TSB - WH01

Models applicable > White 100,120,125,140,145,2120,2135,2155,2155
White/Oliver 1900,1950

Details > with 350mm single recessed flywheel clutch assembly
Ag Clutch Part Numbers > 135 0002 WH
135 0002 WH-L
135 0003 WH-L

AFTERMARKET UPGRADED CLUTCH ASSEMBLY

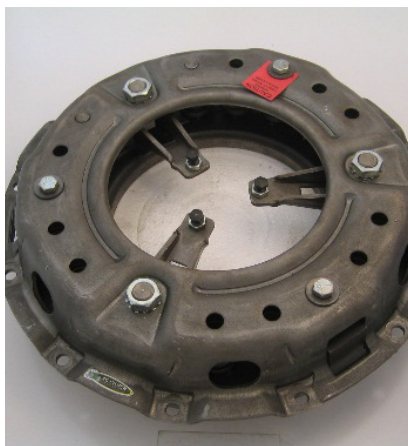
Ag Clutch has two variations of clutch covers available to replace the original "Long" style used in some applications. The clutch covers may vary slightly in appearance. For example the lever and spring arrangement, however these covers are completely interchangeable without the need for any special modification.

The Lipe Rollway style shown is now commonly used in all the later models, and is recommended as an upgrade to the original. It incorporates lever "roller bearings" for longer life and reduced pedal effort, whilst utilizing the cover to provide higher clamp load for increased security against slippage.
